ATLAS Muon MDT

MROD Module:

MROD-X Second Pre-Production Series Test Report

Document Version: 1
Document Issue: 1
Document ID: ATLAS-TDAQ-2007-XXX or EDMS Id XXXXXX
Document Date: 30-Mar-2007
Document Status: Final

Figure 7: ROD Busy LEMO connector (J25) was not assembled

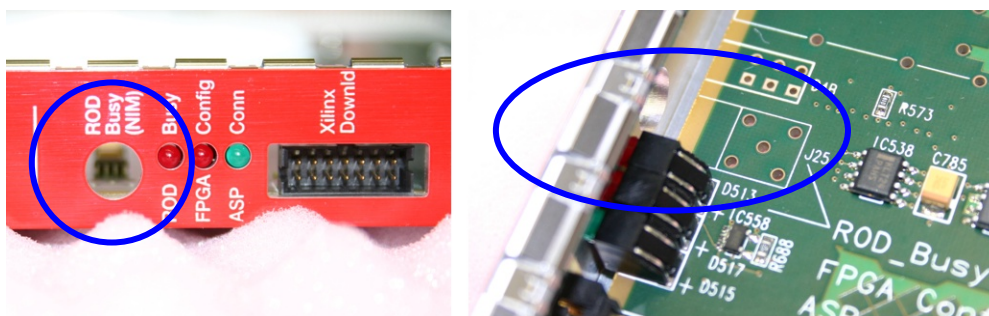
The front panel “ROD Busy” LEMO connector (J25) is one of the items that were properly assembled on the first pre-production series but were not placed on the second pre-production series (see figure 7).

Assemble J25 (ROD Busy LEMO)

Figure 8: Item-29 of another CERN project

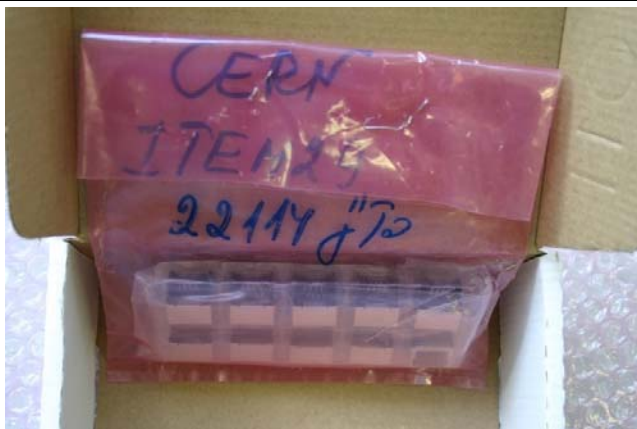
Apparently components had been swapped with other CERN projects since there were ten “RJ45” connectors (figure 8) separately packed. According to PCB-Technologies “these connectors didn’t fit the LEMO connector on the MROD module”. The text on the bag in figure 8 shows “item-29”. By mistake this item was swapped for the MROD project item-29 which is the ROD Busy LEMO connector.

Figure 9: Inferior EMC Gasket was assembled. Encircled is a deformed spring.

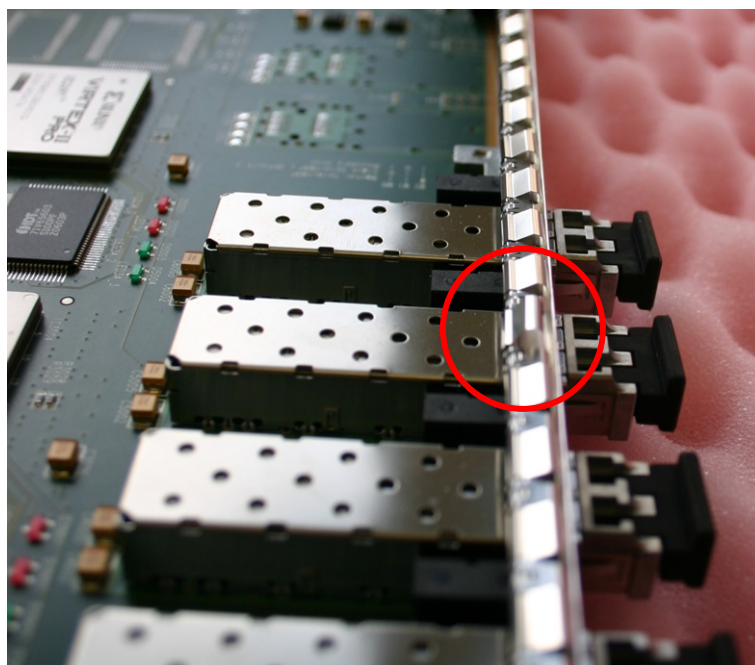
For the second pre-production series it was asked **not** to place the EMC Gaskets (RITTAL number 3686979) since they were found to be of inferior quality on the first pre-production series. However, all second pre-production modules had the EMC Gasket assembled (see figure 9). This figure also shows why the gaskets are of inferior quality; the springs sometimes get deformed which can cause damage on the components that are mounted on neighbouring modules when boards are put into or taken out of a VME Crate.

Do not place the EMC-Gasket. We now have better ones that we will mount in Amsterdam.

Figure 10: M2x12 was used to mechanically fix P1, P2 and P3. Use M2.5x10 instead.

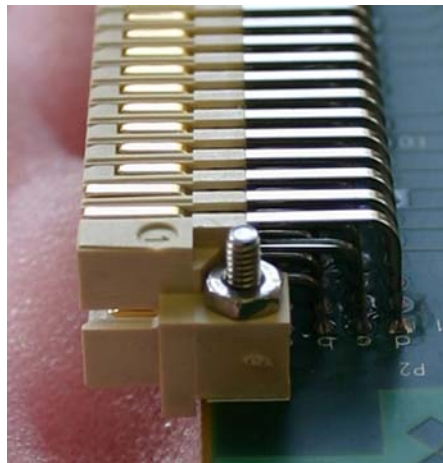
Connectors P1, P2 and P3 were mechanically fixed with M2x12 bolts (figure 10). For the series M2.5x10 should be used. There are two reasons to change to M2.5x10.

First, the holes in the connector and on the PCB are made for M2.5 bolt and thus a M2 bolt has clearance which can lead to a misalignment during the soldering of the connector.

Second, the M2x12 is unnecessary long. To keep maximum clearance to the neighbouring boards M2.5x10 is sufficient.

A sufficient number of M2.5x10 bolts and nuts will be sent from Amsterdam to PCB Technologies so the connectors on the production series can be properly fixed.

Figure 11: a countersunk head M2.5x6 must be used instead of a cheese head

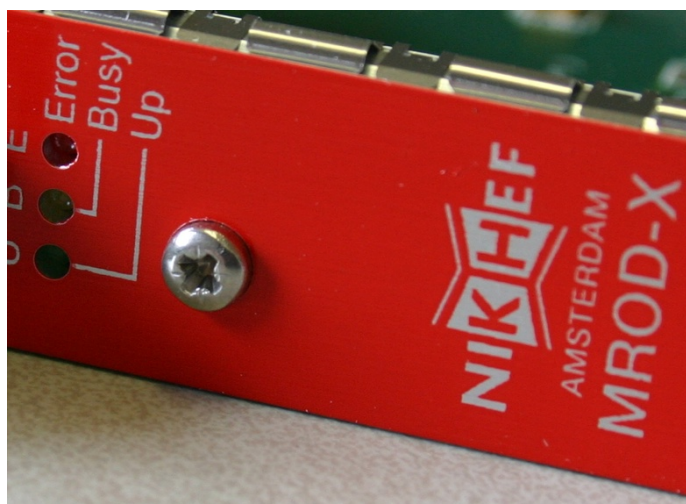
The front panel was properly assembled on the first pre-production series but wrong bolts were used for the second pre-production series (figure 11). The assembly list states on page 19, to use a “countersunk head M2.5x6 for mounting the front panel to the PCB holder”.

A sufficient number of M2.5x6 countersunk head bolts will be sent from Amsterdam to PCB Technologies so the front panel on the production series can be properly fixed.

Figure 12: example of resistors with wrong values

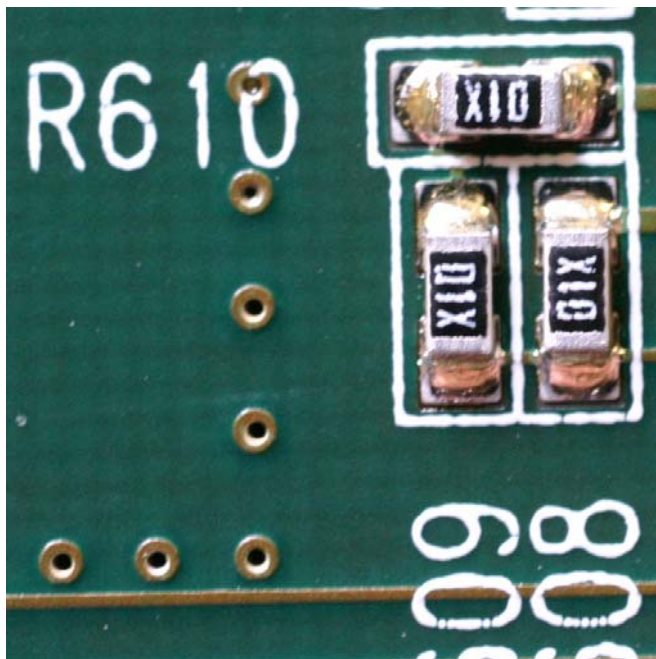
There are many (switched mode) power supplies on the board. The feedback resistors need to have the proper values to avoid over-voltage on the FPGAs or SHARC processors. Not all resistors had the proper value. It seems that there was a wrong tape placed on the machine since for all 100 ohm resistors, 10 ohm resistors were placed instead. This involves 15 resistors per module (R605, R608, R609, R610, R719, R720, R721, R1006, R2006, R3006, R4006, R5006, R6006, R7006, R8006)

The proper EIA-96 marking for a 100 ohm SMD resistor should read “01A”. However 10 ohm resistors with marking “01X” were placed.

It should be noted that the same error was made in the first pre-production series!

R605, R608, R609, R610, R719, R720, R721, R1006, R2006, R3006, R4006, R5006, R6006, R7006, R8006 **must be 100 Ω** (not 10 Ω)

Figure 13: Example; R714 must **not** be placed, R715 must be a **0603** package, not a 0805 package

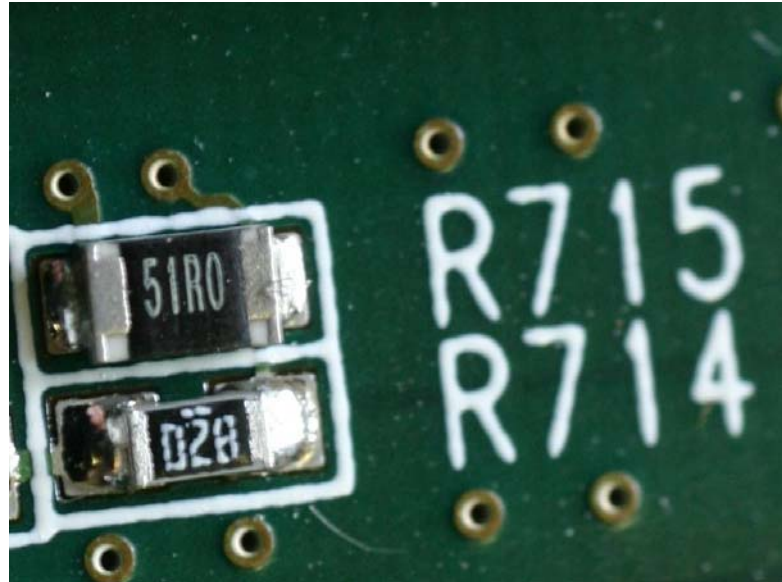
New insights from the first pre-production series led to the instruction **not** to place R710, R712, R714, R716. This instruction was not followed as can be seen in figure 13.

New insights from the first pre-production series led to the instruction to replace R711, R713, R715, R717 by a 51 ohm resistor. This instruction was indeed followed, however a **0603 SMD size must be used**, not a 0805 (see figure 13).

Don't place R710, R712, R714, R716

Place R711, R713, R715, R717 = **51 Ω** (not 130 Ω) **in 0603 package**

Figure 14: J24 pins 56 and 58 are shorted

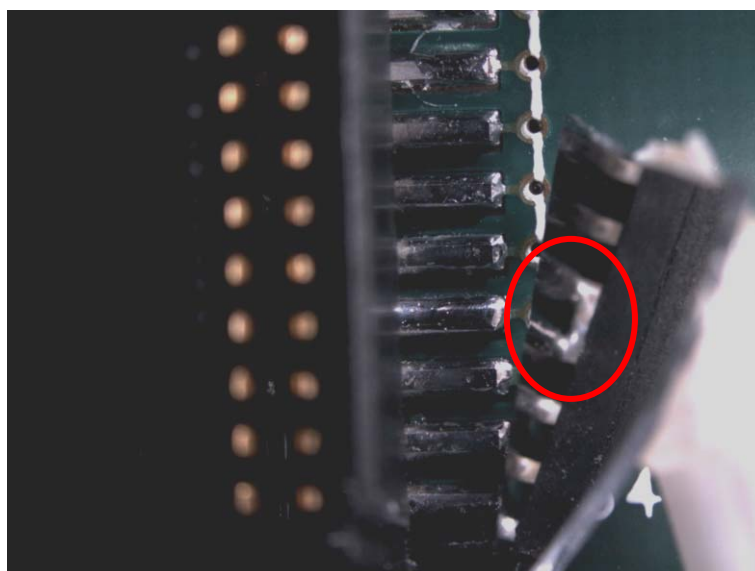
This module did not pass the test and software soon pointed to connector J24 pins 56 and 58. It appeared that PCB technologies had done some rework on pins 52 to 64. After closer inspection with a tiny mirror, one can see that there is a short between pins 56 and 58 (see figure 14).

Figure 15: IC588 pin 1 and 5 above the PCB and not soldered

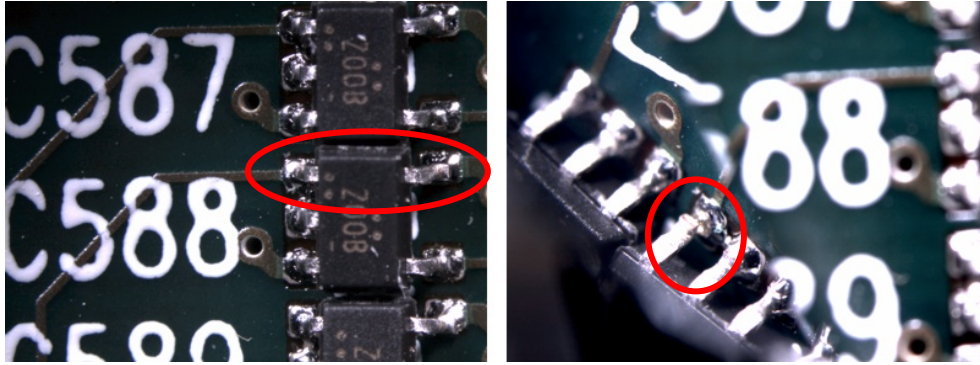
This fault is caused by the package of the NC7SZ00P5X which is not really flat on the PCB thus causing the pins to stand off from the PCB surface (see figure 15).

This problem area was already noticed while testing the first pre-production series and it was recommended to pay extra attention to IC588. This fault proves that extra attention for IC588 is indeed necessary!

Keep paying special attention to IC588 area
